**GERALD PLAZA**  
1760 EAST AUBURN ROAD  
ROCHESTER HILLS, MI 48307

Reference: **Gerald Plaza**  
**CAMS #202400137**  
**Part of the NE ¼ of Section 36, City of Rochester Hills**

# SITE PLAN.pdf Markup Summary

<b>BUILDING ELEVATIONS</b>	
<b>A-10</b>	
<b>GERALD PLAZA</b>	
1780 EAST AUBURN ROAD ROCHESTER HILLS, MI 48307	
CONTACT :	MIKE CHAUDHARY
OWNER :	GERALD REAL ESTATE LLC
ADDRESS :	13500 FOLEY STREET, DETROIT, MI 48227
PHONE :	313-491-1815
E-MAIL :	mike@dmcgroupusa.com
	<b>24002</b>

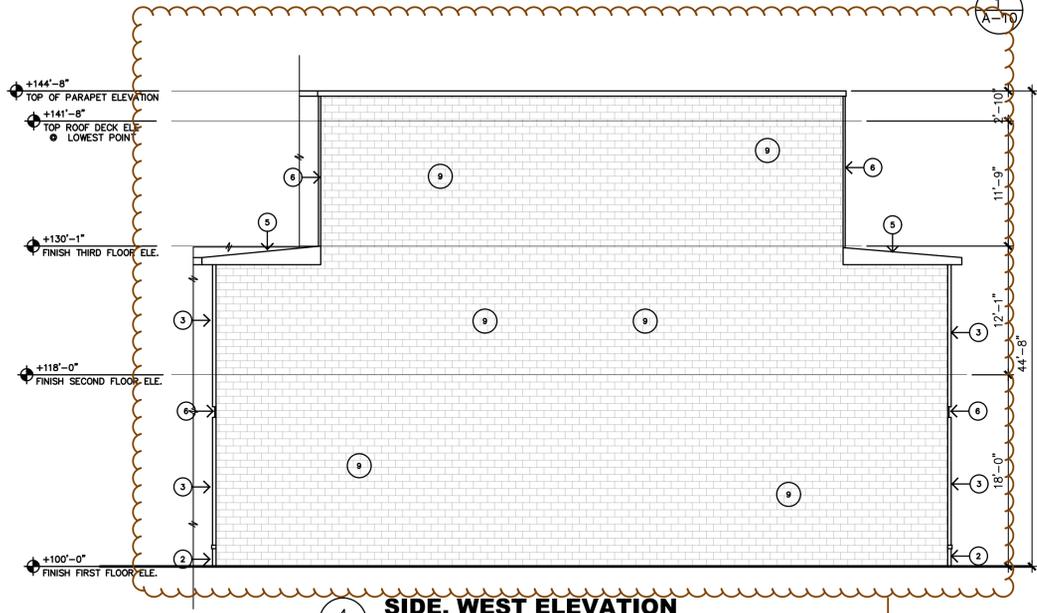
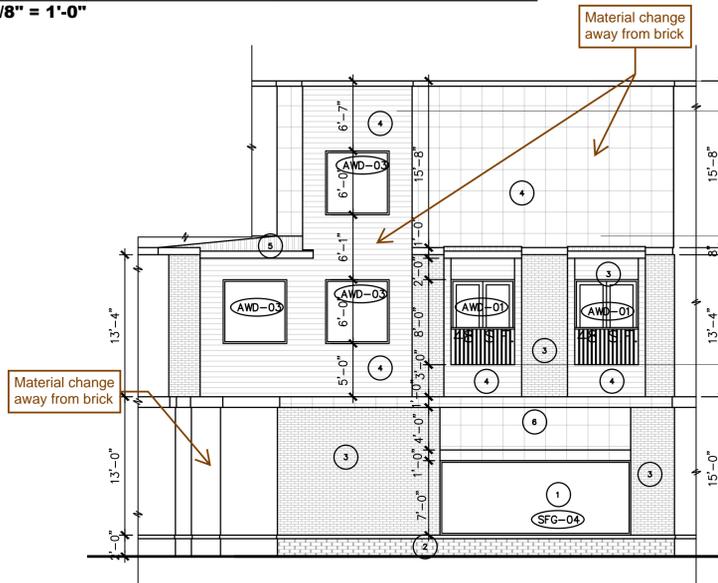
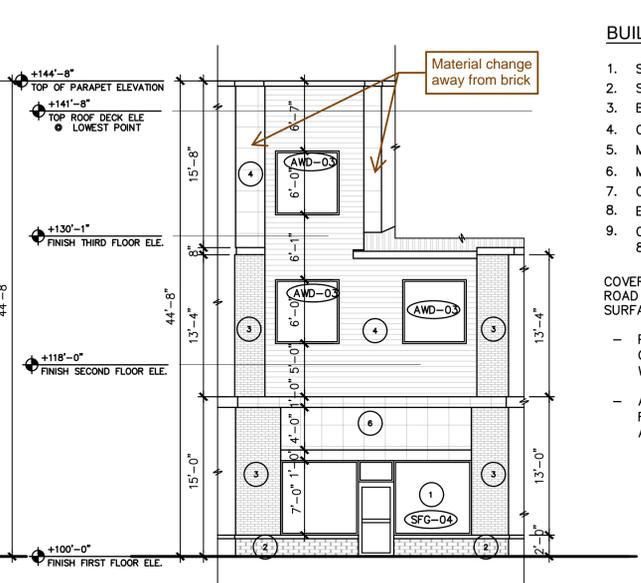
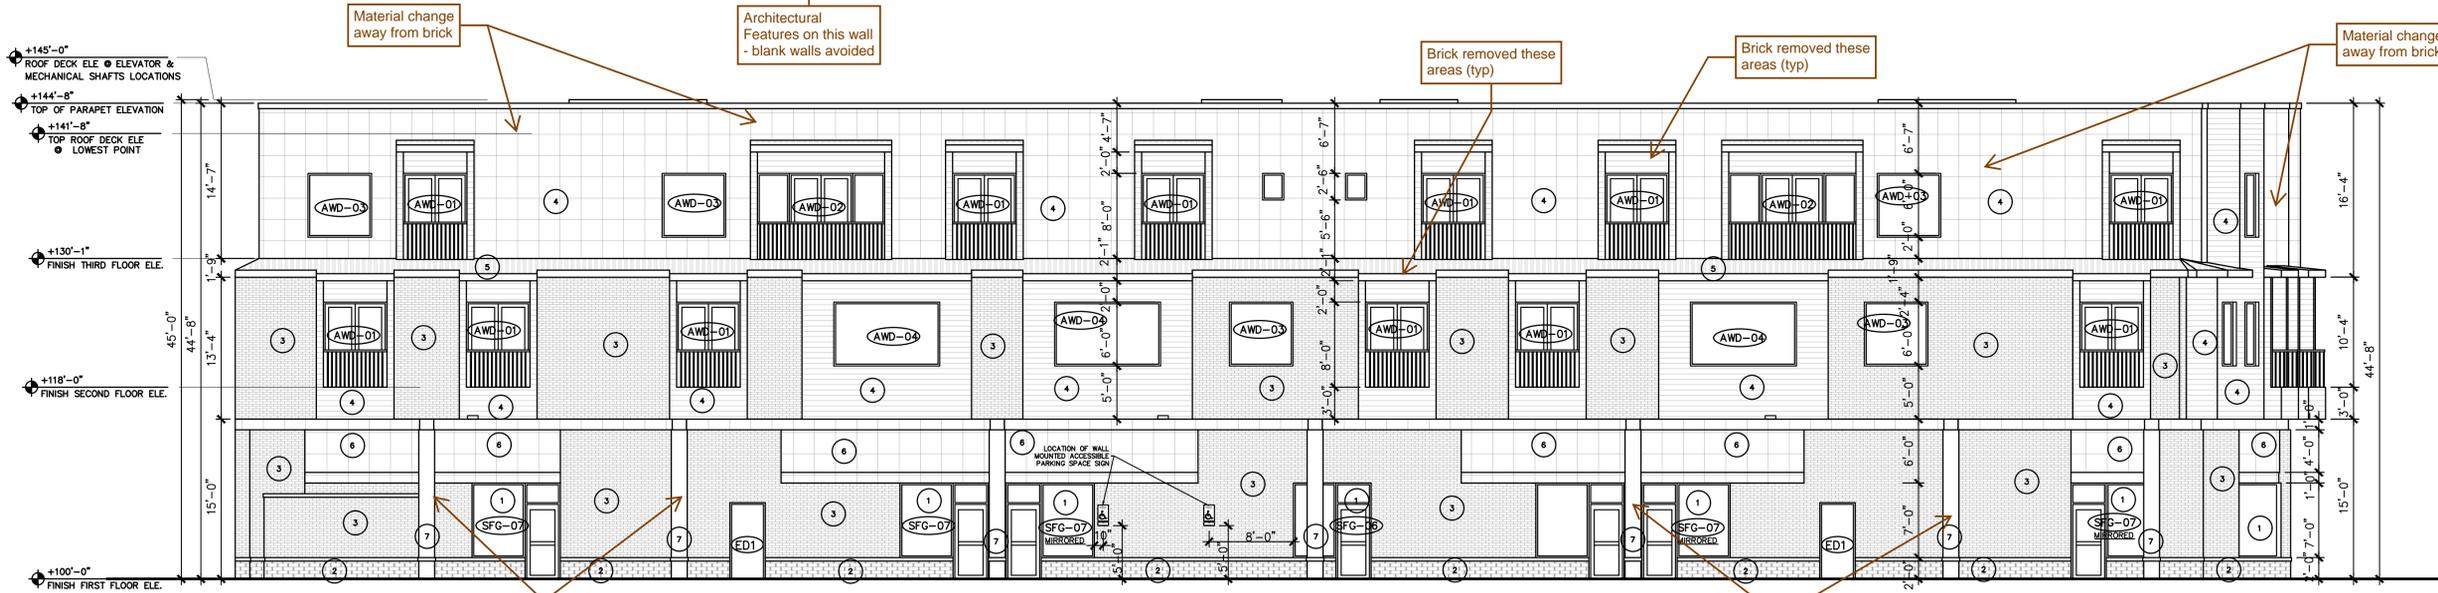
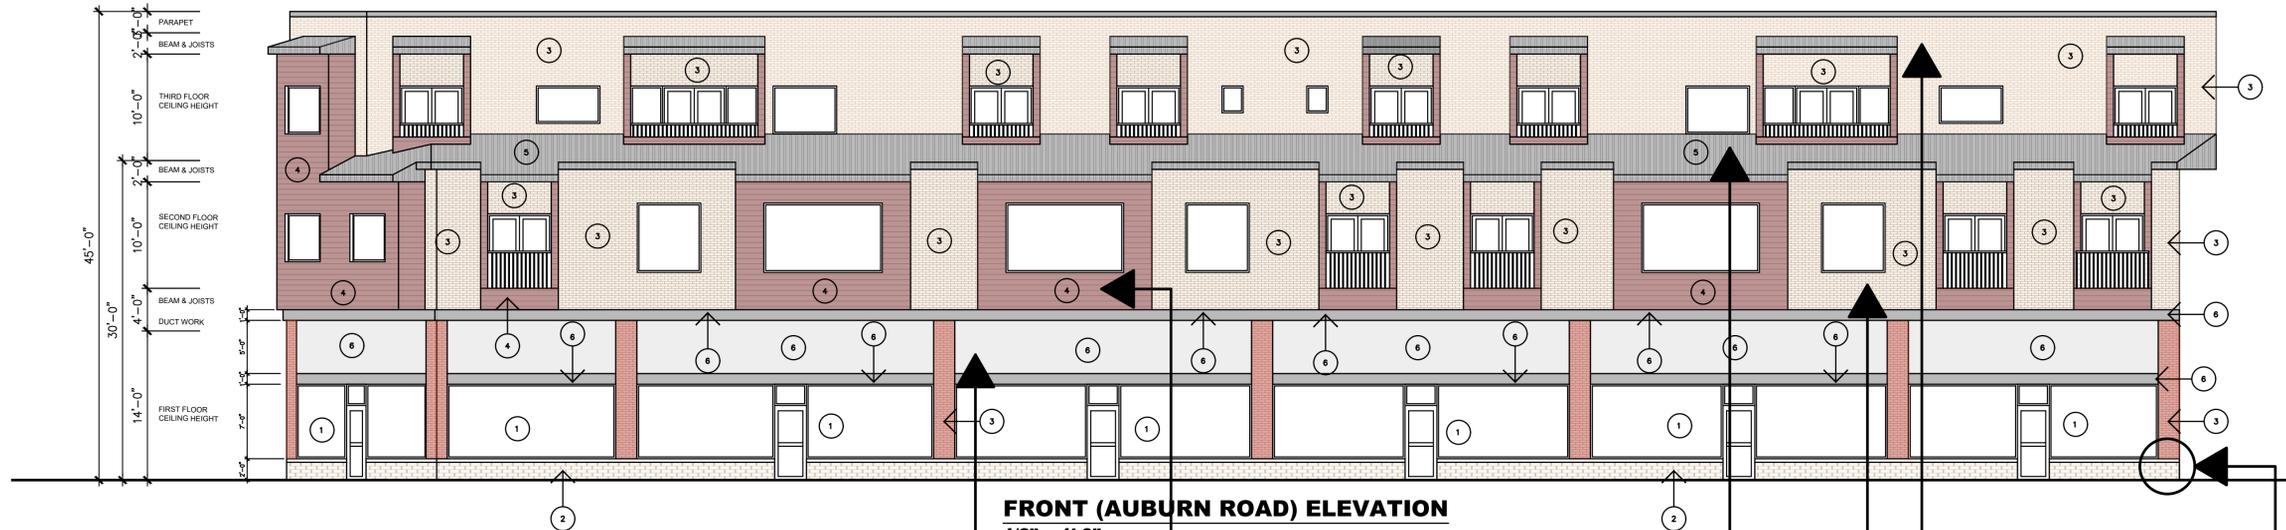
Architectural Features on this wall - blank walls  
 avoided

Brick removed these areas (typ)

Material change away from brick

Material change away from brick

Material change away from brick

Material change away from brick

Brick removed these areas (typ)

Brick removed these areas (typ)

Brick removed these areas (typ)

Material change away from brick

Material change away from brick

Material change away from brick
